Servicing / Technical bulletin number: 089

Subject: Change to Crewsaver operating Head torque wrench

Change to Crewsaver operating Head torque wrench 10465

Modified socket

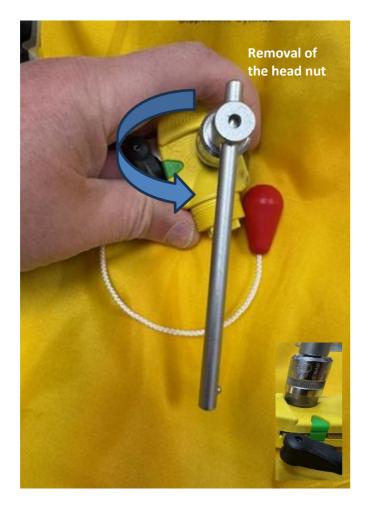
The supplier of the calibrated torque wrench part code 10465 has stopped manufacture to this item.

This has been replaced by a new version of the torque wrench and a T-Bar.

They will be supplied under the same Part code. (10465)

The T-bar replaces the welded ¼ drive point on the head of the old tool, that was used to remove the nut from the UML and HR Heads.

The New version tool is supplied with the modified socket which is required when removing the UML operating Heads (this must be used as a Standard socket can damage the nut.)

Single socket code R47241

Please ensure the correct approved tools are used for removal and replacement of the operating head.

NOTE. The old version tool is still approved to use and does not need to be changed.
